ALERT SERVICE BULLETIN

206-24-143

SUBJECT: TAIL ROTOR SEGMENTED DRIVESHAFT

ASSEMBLY, ONE-TIME INSPECTION OF

Figure 1 - Tail Rotor Drive System

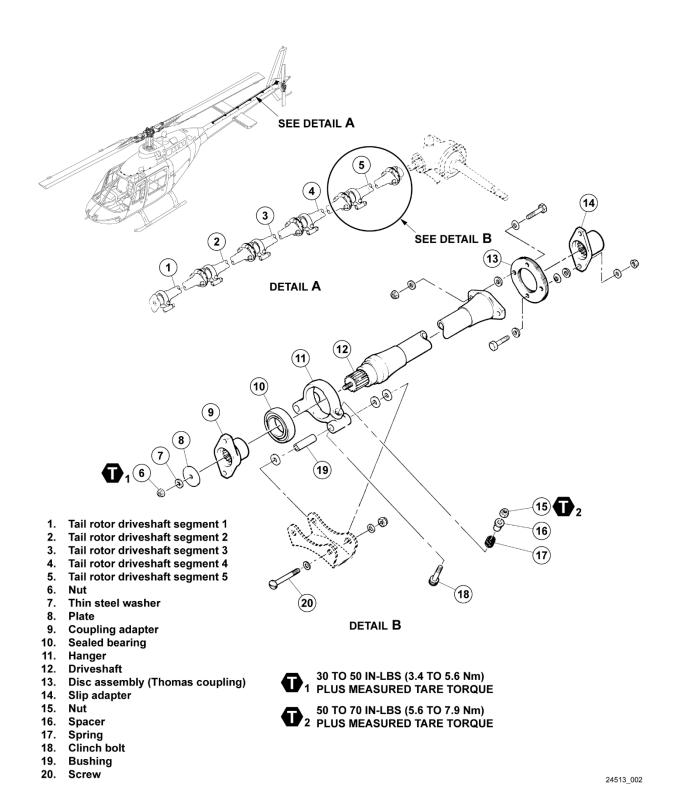
Bell has received reports of looseness of the splined adapter on the tail rotor driveshaft segment assembly. The investigation noted that the retaining nut holding the splined adapter to the driveshaft was found with less than the required torque.

This Alert Service Bulletin (ASB) is being released to require a one-time inspection and re-torque of the splined adapter retaining hardware.

- 3. Inspect the tail rotor segmented driveshaft assembly splined adapters (9, Figure 1) for any noticeable axial (fore and aft) and radial play between the splined adapter (9) and the driveshaft (12) at all five locations (Figure 1).

- a. If there is no radial or axial play noted, do the following:
 - (1) Remove the aft short shaft directly aft of the fan shaft and the segmented shaft assemblies (2) and (4). Support the aft end of the segmented shaft (1) and (3) (BHT-206A/B-SERIES-MM, Chapter 65).

- (2) Remove any torque seal lacquer (C-249) that may be applied to nut (6) on all five of the tail rotor segmented driveshaft assemblies.
 - (3) Unseat the nut (6) by loosening the nut by ½ to 1 turn at each of the five tail rotor segmented driveshaft assemblies.

- (4) Measure the tare torque of the nut (6) using a dial indicator torque wrench.
 - (a) If the tare torque of the nut meets the minimum 3.5 inch-pounds (0.4 Nm), go to step (3.a.(5)).

- (b) If the tare torque of the nut is less than 3.5 (0.4 Nm), replace the nut with a serviceable nut and proceed to step (3.a.(4)(a)).
 - (5) Torque the nut (6) 30 to 50 inch-pounds (3.4 to 5.6 Nm) and add the measured tare torque in steps (3.a.(4)) to the specified torque.

- (6) Apply torque seal lacquer (C-249) across the threads of the stud of the driveshaft (12), the nut (6) and the plate (8). Go to step (4).
 - b. If radial or axial play is noted, perform the following:

- (a) Inspect the splined adapter (9) and splines of the driveshaft (12). Replace or repair parts if required (BHT-206B3-CR&O).
- (3) Assemble the applicable tail rotor driveshaft assembly with serviceable parts (BHT-206B3-CR&O).

- (a) Measure the tare torque of the nut (6) using a dial indicator torque wrench.
 - 1. If the tare torque of the nut meets the minimum value of 3.5 inchpounds (0.4 Nm), go to step 3.b.(3)(b).

- <u>2.</u> If the tare torque of the nut is less than 3.5 inch-pounds (0.4Nm), replace the nut with a serviceable nut and repeat step (3.a(4).
 - (b) Torque the nut (6) 30 to 50 inch-pounds (3.4 to 5.6 Nm) and add the tare torque measured in step 3.a(4) to the specified torque.

- (c) Apply torque seal lacquer (C-049) across the threads of the driveshaft stud (12), the nut (6) and the plate (8).
- 4. Install the tail rotor segmented driveshaft assemblies 2 and 4 (BHT-206A/B-SERIES-MM, Chapter 65).
